UNITED STATES PATENT AND TRADEMARK OFFICE

10/667,825

Office Action Summary

DETAILED ACTION

Sheet 2 of 4

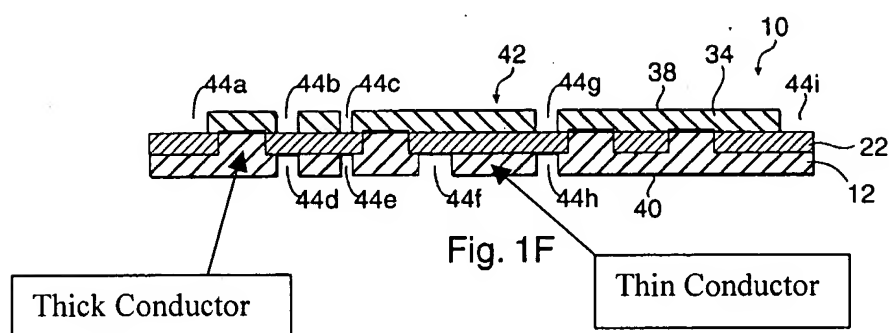
- forming predetermined printed circuits (Fig. 1F, 10) having both thick conductor traces formed from the thick conductive material (Fig. 1F, see below) and fine resolution traces from the thin base (Fig. 1F, see below) by/and removing conductive material (Fig. 1F, elements 44d-44f) from the flat laminate that does not comprise said predetermined printed circuits (Fig. 1E, 40) to form the predetermined printed circuits (Fig. 1G, 48).

It would be obvious to one of ordinary skill in the art at the time the invention was made to combine the two teachings by having conductive layer set with dielectric material, as taught by Gilleo et al and not its general structure, to the method for making circuit board as taught by

Patel et al with the conductive material set next to the dielectric one, as a simple process to lay the dielectric material on a conductive one.
